Office Action Summary

10/528,213

DETAILED ACTION

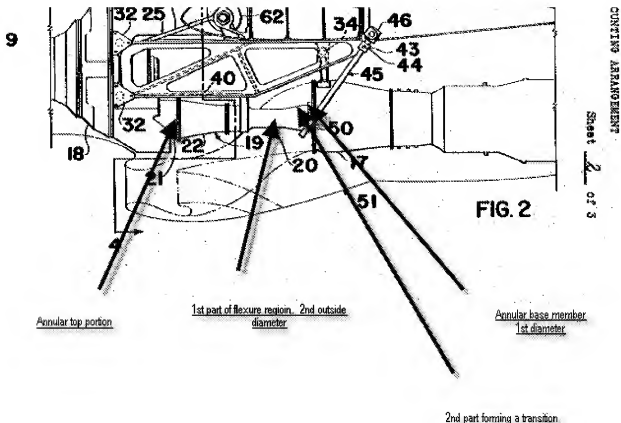
Sonneborn et al teaches forward mount (which is 203) and aft mount 205 (having a bipod support). Sonneborn et al is silent on the forward mount having the base portion, top portion, and flexure region as claimed. However, Danic teaches a forward mount having a base portion, top portion, and flexure region that has a first part with a second diameter and a second part forming a transition between the second diameter and the first diameter. Please note that the transition occurs from the second diameter to the first diameter due to the different size diameters. This creates a slope. The claimed parts are shown below.
